From: Pollock, Heather
 To: Richardson, Jason R (KYTC-D05)
 Subject: RE: 23-SIGNPERMIT-0116 for 7709 Bardstown Rd.
 Date: Friday, October 6, 2023 1:03:00 PM
 Attachments: [image001.png](#)
[image002.png](#)
[image003.png](#)

From: Pollock, Heather <Heather.Pollock@louisvilleky.gov>
Sent: Tuesday, September 12, 2023 2:43 PM
To: Richardson, Jason R (KYTC-D05) <JasonR.Richardson@ky.gov>
Subject: 23-SIGNPERMIT-0116 for 7709 Bardstown Rd.

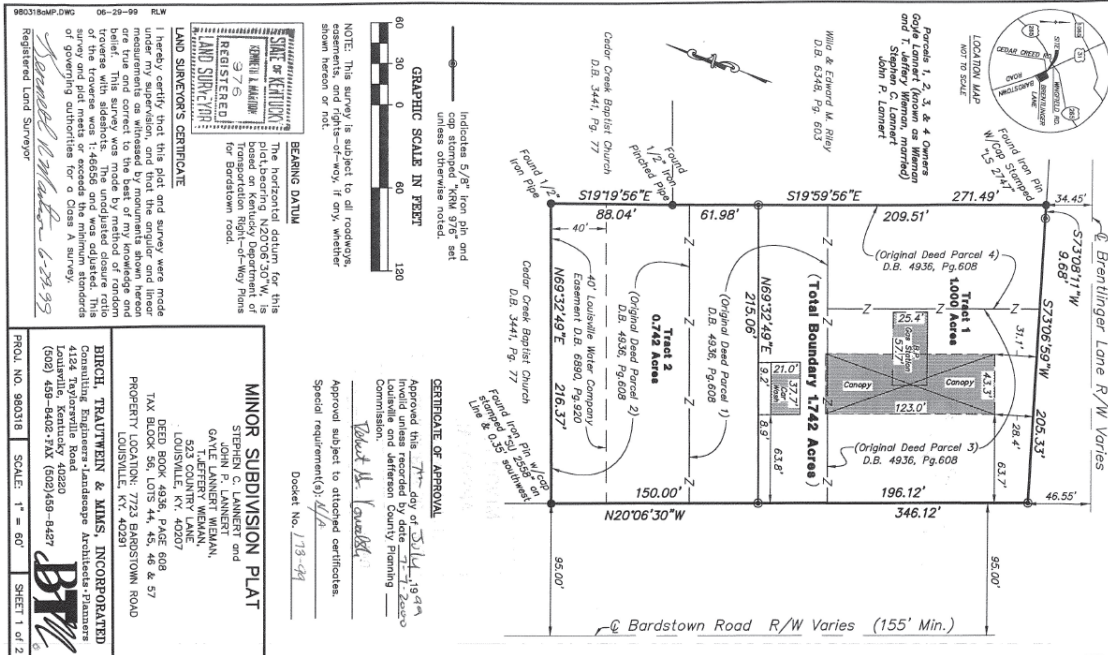
Jason,
 I found this minor plat for the neighboring property which labels survey markers for the southern property line of our subject site. I have forwarded this plat to the applicant so that they can use the survey pins to determine their front property line and ensure that the new sign will not encroach into the right of way.

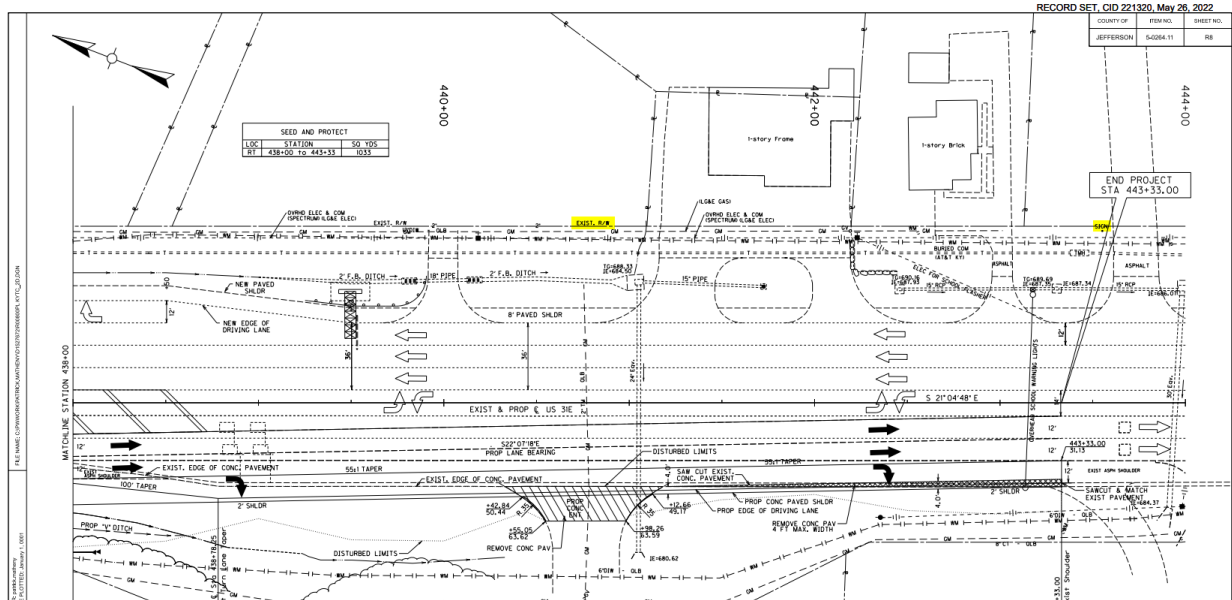
Well, maybe. It's hard to tell. Without going out there and wheeling it off, I'm not exactly sure where the ROW line is in relation to those signs.

Jason,
 I have a follow up question about this one. When I visited the sign I saw that there was a historical marker sign directly in front of the church's monument sign. Is it possible that this might be the sign identified in the

plan below?
Thanks,
Heather

As it turns out, the existing sign is just on ROW, per the plan sheet below. If they wish to modify the sign at all, it will have to be moved off of state ROW.
